4PPoE Architecture Proposal 2.0

Dave Dwelley, Linear Technology

Bill Delveaux, Avaya

Legalize Four-Pair Power

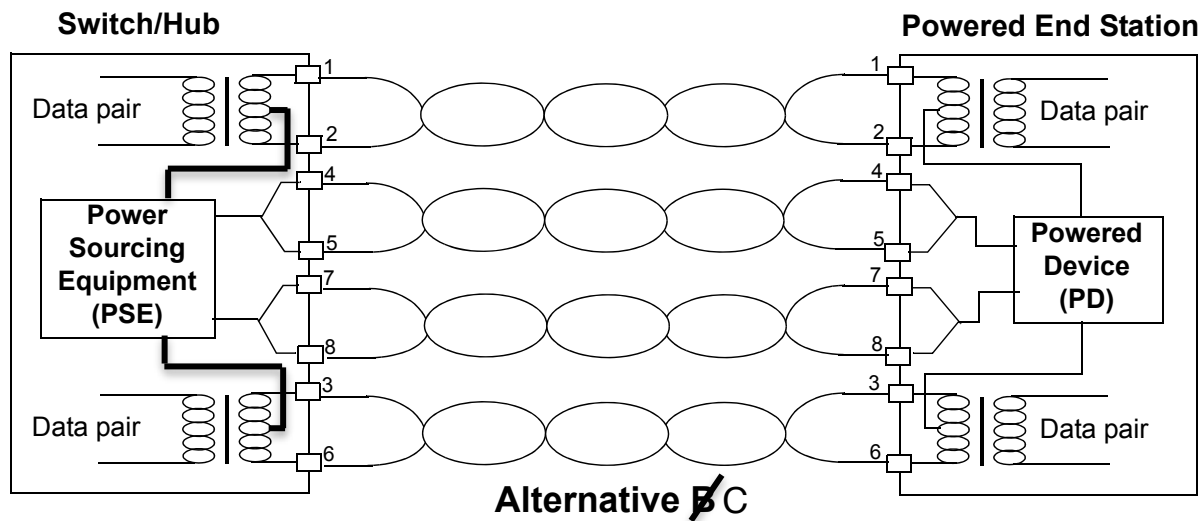
- Add new “Alternative C” to 33.2.1, Figures 33-4... 33-7, and Table 33-2
 - Modify PSE to touch all 4 pairs (PDs already touch all 4 pairs)
 - Define a single Alt-C polarity (like Alt-B)
 - Edit PSE state machine 33.2.4.7 to add Alt-C
- Change 33.2.3: allow PSE to power using Alt-C
- Change 33.3.1: allow PD to receive Mode A and Mode B power simultaneously
 - “Mode C” not needed the way the text is currently written

New Type 3

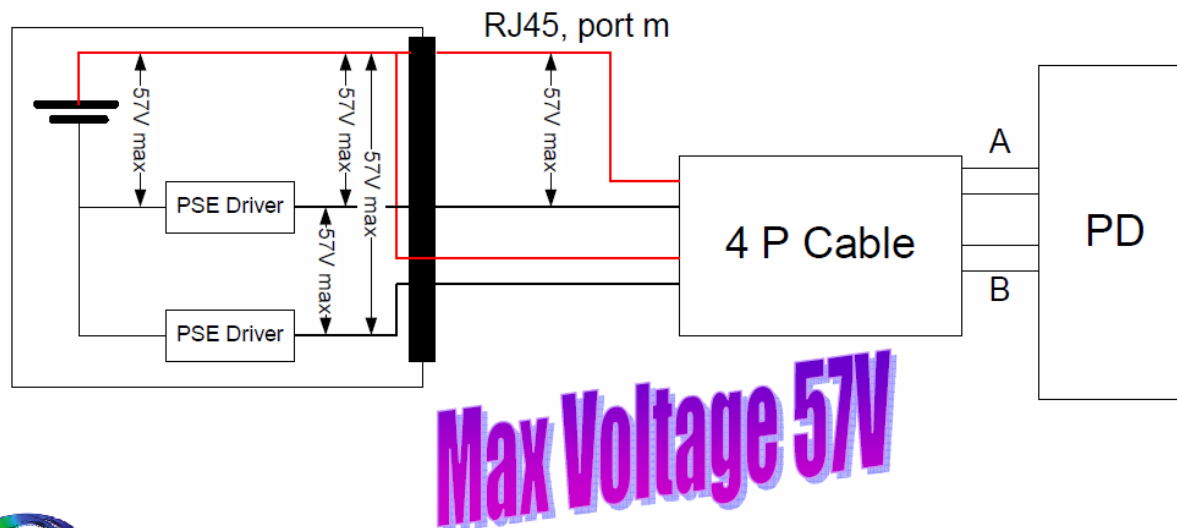
- Modify 33.2.5 to require a Type 3 PSE to power all four pairs if a PD is connected via a valid four-pair channel
- Add new sections 33.2.6.3 and 33.3.5.3 to describe Type 3 classification
 - Classification details TBD
 - Define new class power levels TBD, adjust Table 33-11 and 33-18 limits accordingly
 - Modify both state machines for new class behavior
